16/2022/0894

**Clwyd Gate Motel-
Main building**

**Provision of external alterations, lighting and
associated works
(retrospective application)**

APPLICATION NO: 16/2022/0894/ PC

Site plan showing locations of lighting reduced

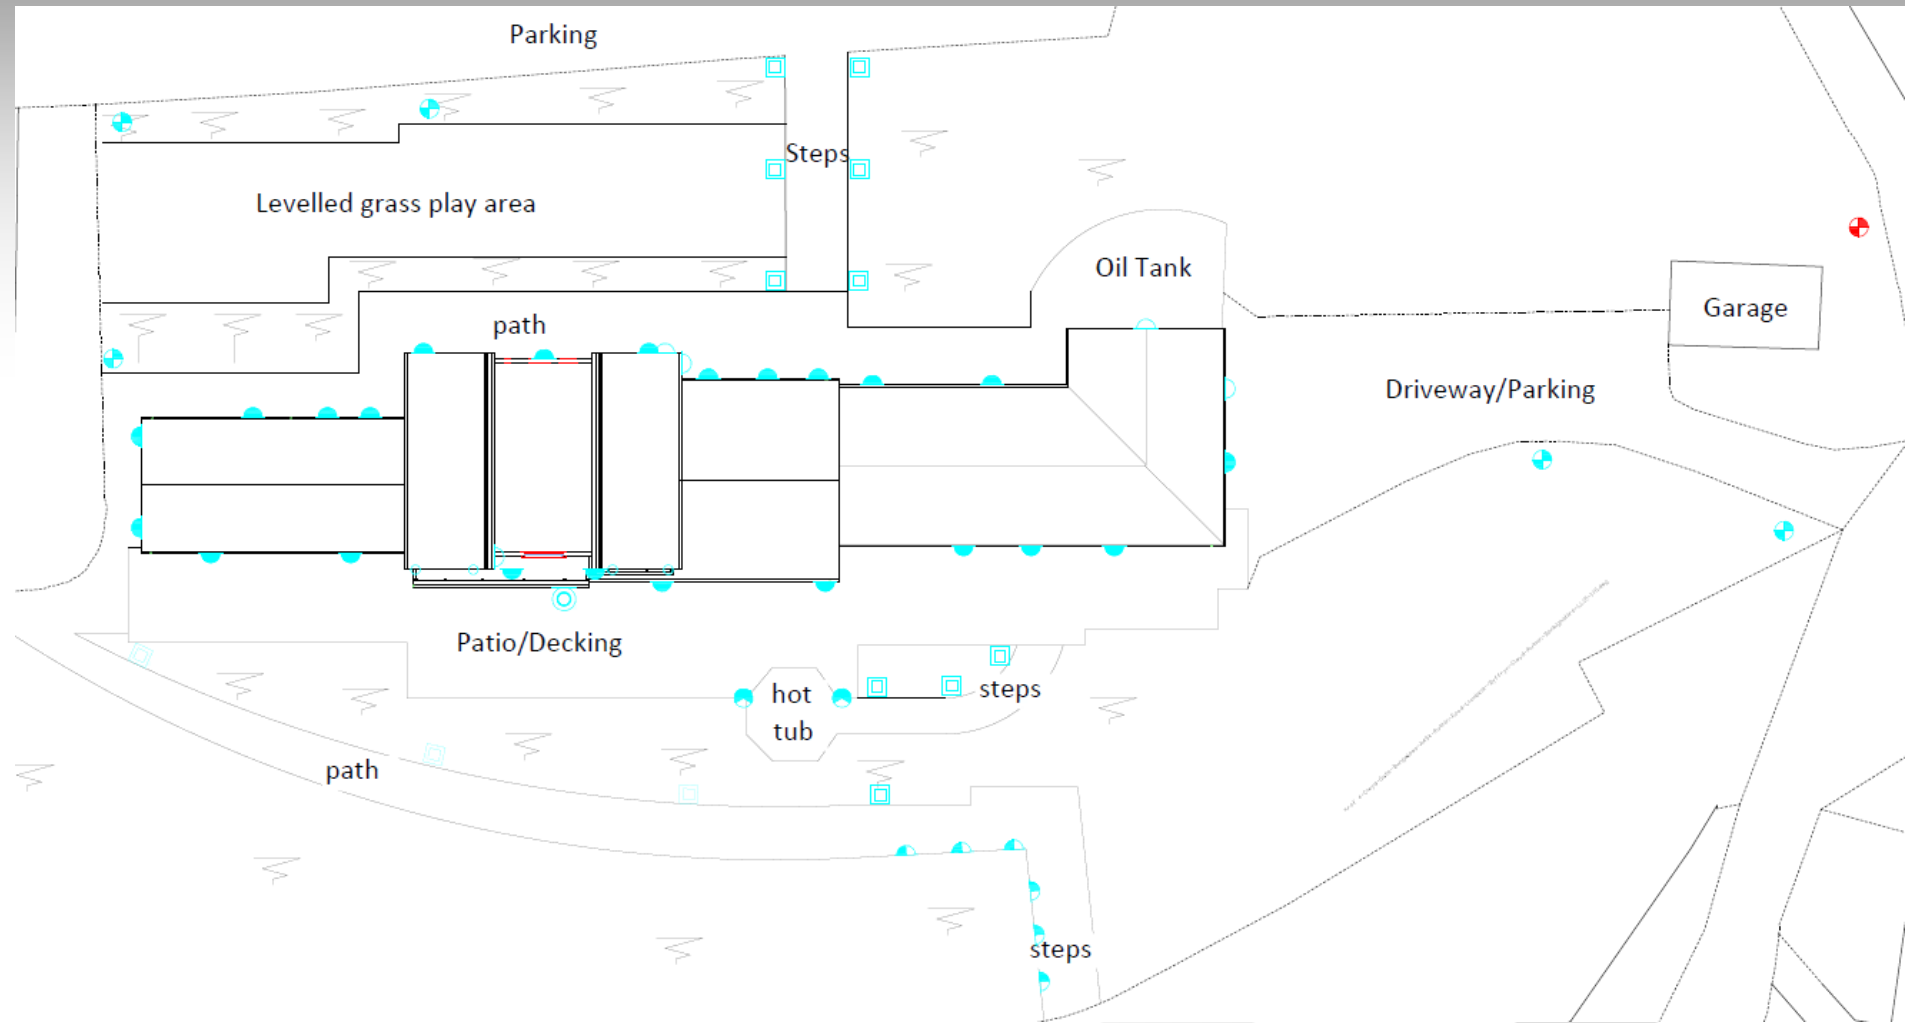
- 1.1.10 The 3 flood lights in grass verge, aimed at hot tub are proposed to be removed.

As completed front and rear elevations with external lighting shown as reduced

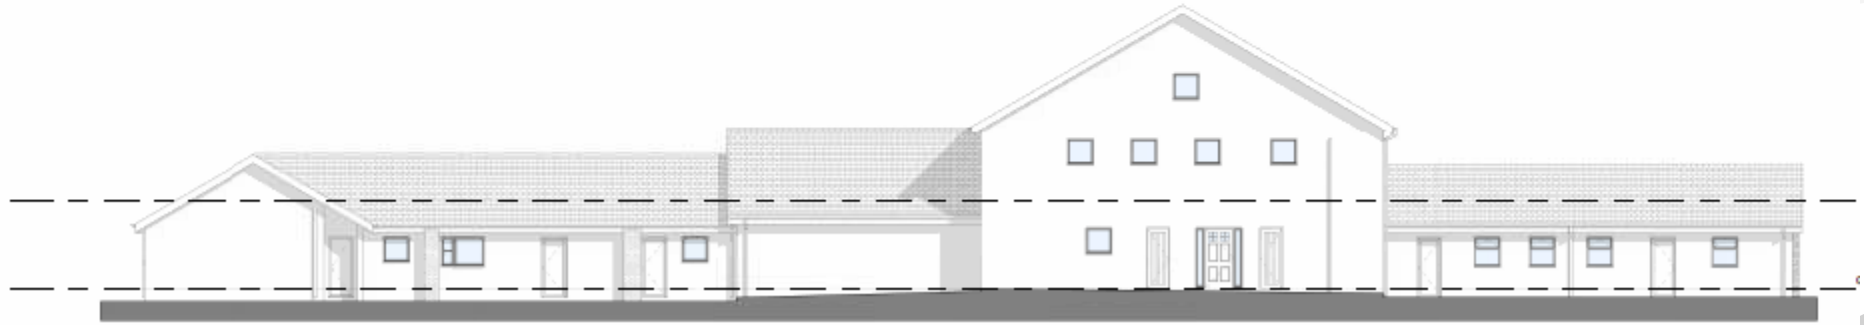
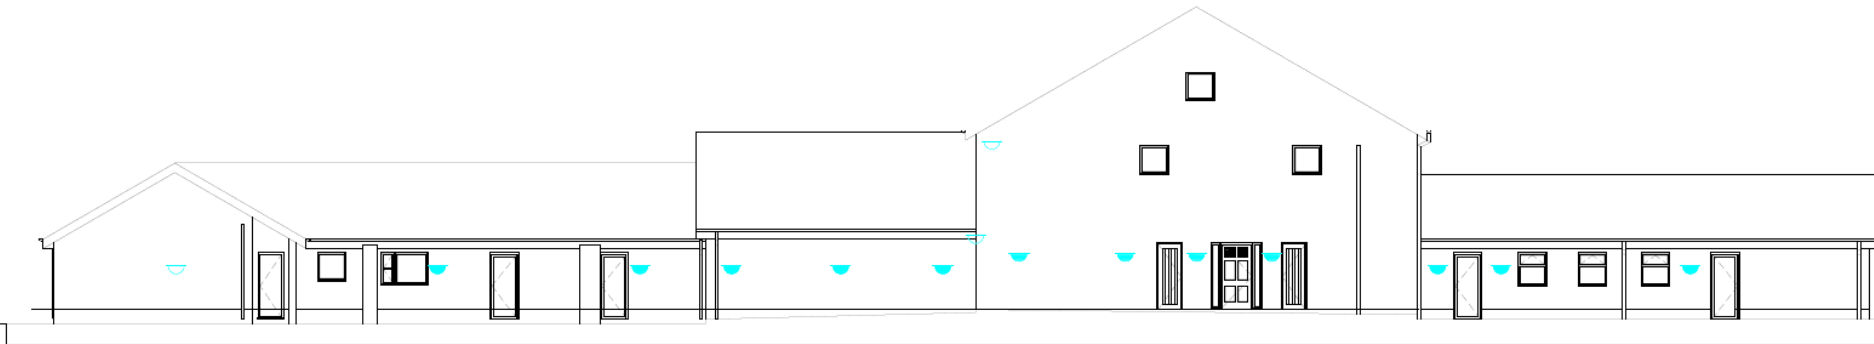
- 1.1.4 Originally had 10 soffit lights within the eaves of the gable. 3 have been proposed to be removed on each side leaving 2 soffit lights within the gable.

- 1.1.5 The security lights to the front are to remain but are to be angled horizontally on a 1min timer.
- 1.1.6 Originally had 4 up/down lights at first floor level. 2 have been proposed to be removed and down facing only.

- 1.1.7 Originally had 11 up/down lights to the ground floor between the windows. 4 have proposed to be removed.
- 1.1.8 Originally had 2 bulk head lights to each side of the door onto the terrace. One bulk head to the side of the door has proposed to be removed.

- 1.1.9 Originally had 4 up/down lights and a security light to the side elevation facing the bat roost. 3 up/down lights are proposed to be removed and the security light is to remain.
